AGENDA
DESIGN COMMISSION
Community Room, 3rd Floor
Arlington Heights Village Hall, 33 S. Arlington Heights Rd.
Arlington Heights, IL 60005
July 22, 2025
6:30 PM

MINUTES OF THE VILLAGE OF ARLINGTON HEIGHTS DESIGN COMMISSION

ARLINGTON HEIGHTS MUNICIPAL BUILDING
33 S. ARLINGTON HEIGHTS RD.
JUNE 24, 2025

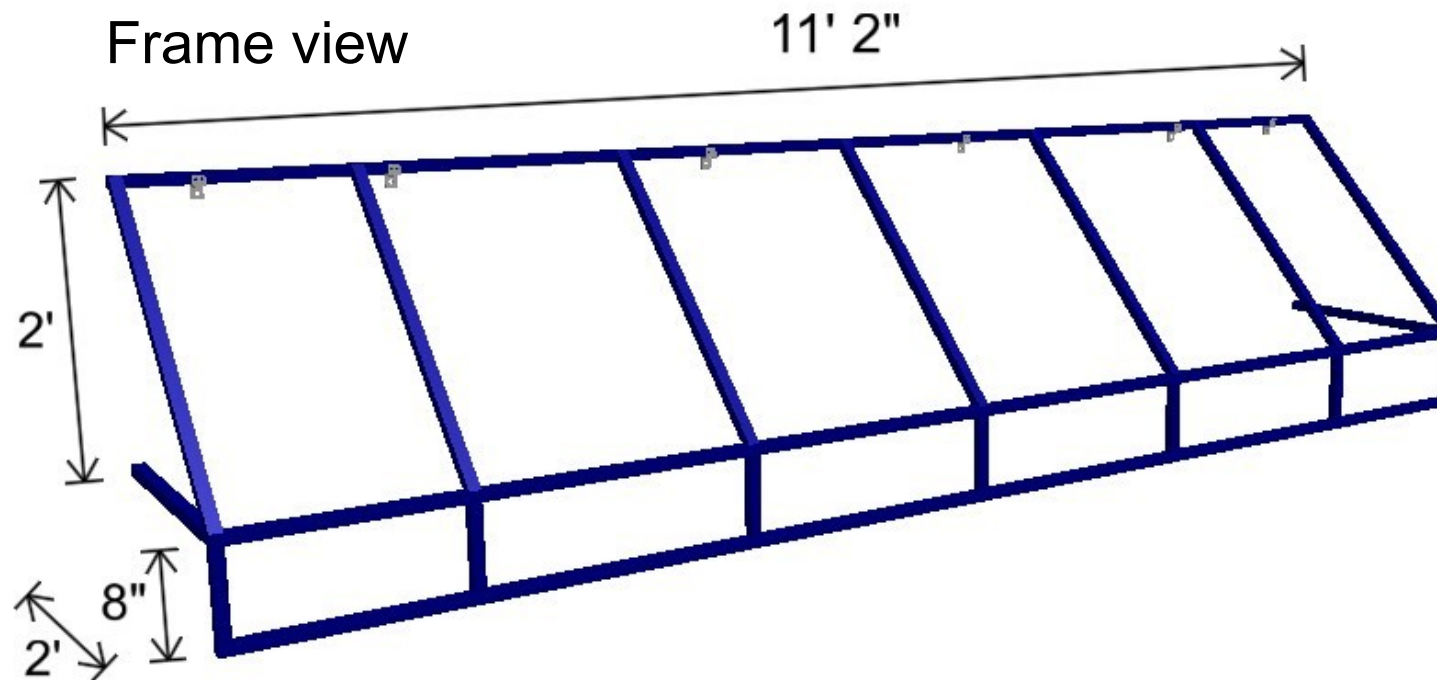
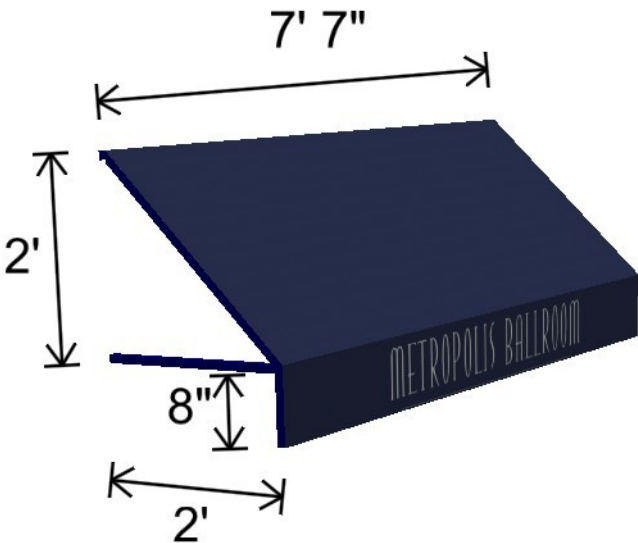
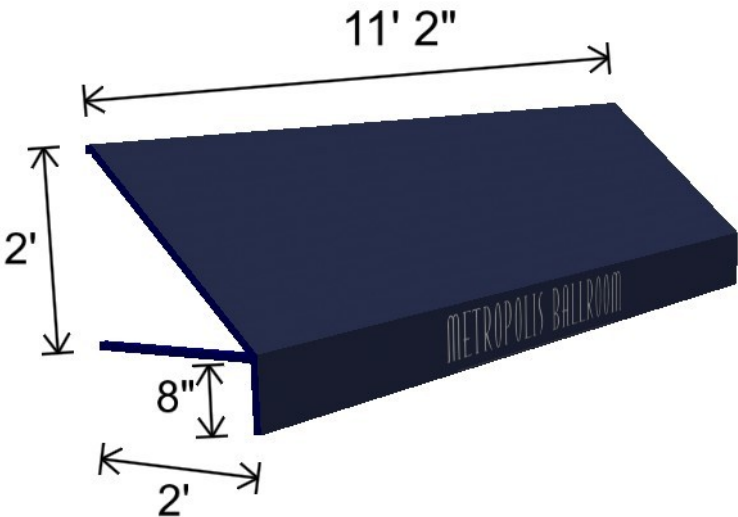
STAFF ALTERNATE RECOMMENDATION:
CONSIDER SIMILAR SMALL "METROPOLIS
BALLROOM" BANNERS MOUNTED BETWEEN THE
WINDOWS IN LIEU OF AWNINGS COVERING THE
WINDOWS.
